HISTORIC AND DESIGN REVIEW COMMISSION

December 19, 2018

HDRC CASE NO: 2018-462
ADDRESS: 201 E HUISACHE AVE
LEGAL DESCRIPTION: NCB 3085 BLK 1 LOT 23
ZONING: MF-33
CITY COUNCIL DIST.: 1
DISTRICT: Monte Vista Historic District
APPLICANT: Patrick Christensen
OWNER: SA Huisache Investors LLC
TYPE OF WORK: Window replacement
APPLICATION RECEIVED: November 20, 2018
60-DAY REVIEW: January 19, 2018
REQUEST:

The applicant is requesting a Certificate of Appropriateness for approval window replacement and a window master plan in response to the commission action at the HDRC hearing on August 19, 2018.

First floor
O = old wood
X = new vinyl

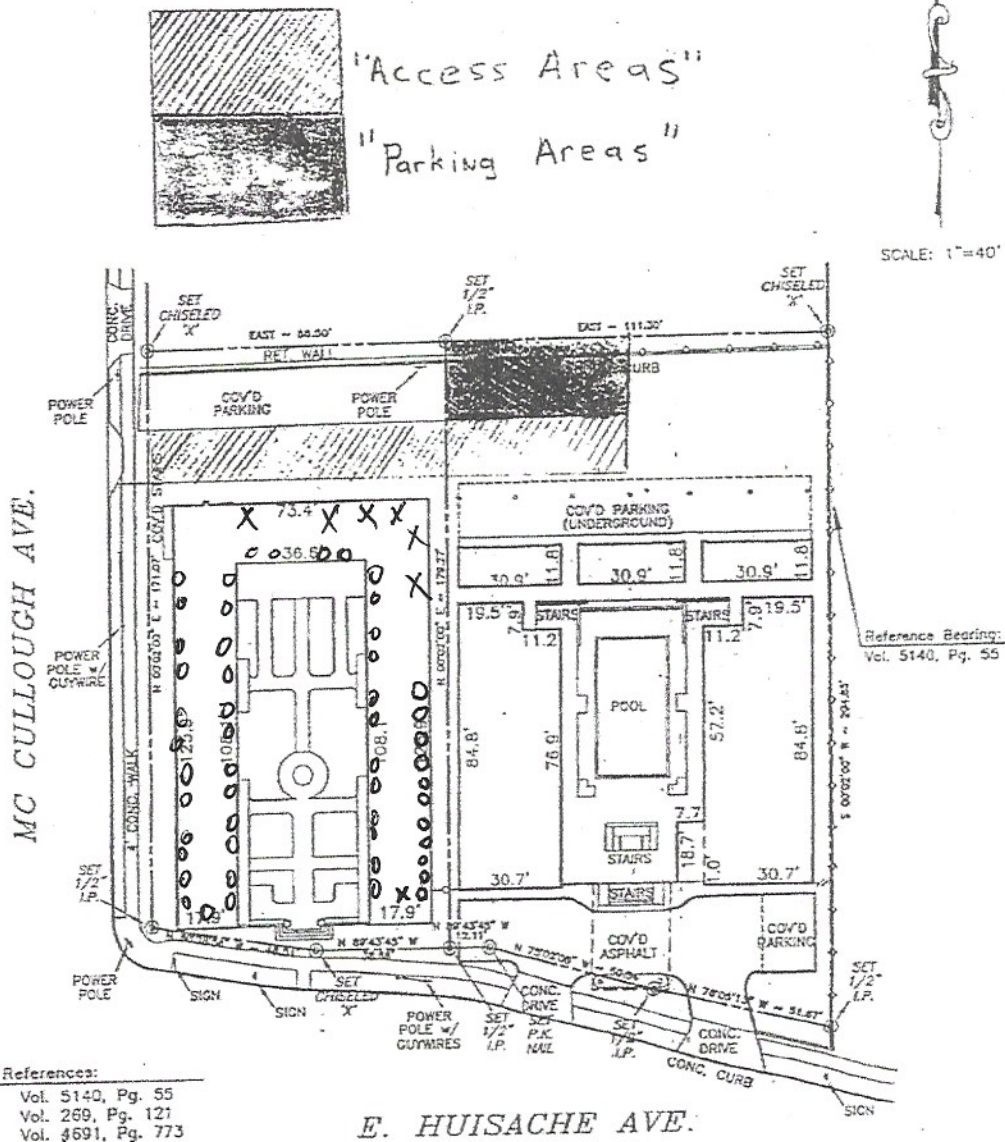
- e. WINDOW REPLACEMENT – The applicant has proposed to replace a number of wood windows and doors with new vinyl windows. The Guidelines for Architectural Features 6.B.iv. notes that window replacement should only be considered when the original windows are deteriorated beyond repair. While the applicant does provide some supporting evidence regarding wood element failure or broken glazing, staff finds that many of the windows are can potentially be repaired. Wholesale window replacement is not consistent with the Guidelines.

- f. NEW WINDOWS – The applicant has proposed to install black one-over-one vinyl windows. The Guidelines for Architectural Features 6.B.iv. notes that new windows are to match the historic or existing windows in terms of size, type, configuration, material, form, appearance, and details. Staff finds that the proposed windows are not compatible in style or materials with the original windows.

Staff does not recommend approval as proposed based on finding b through f. Staff recommends in-kind wood window replacement where they are deteriorated beyond repair.
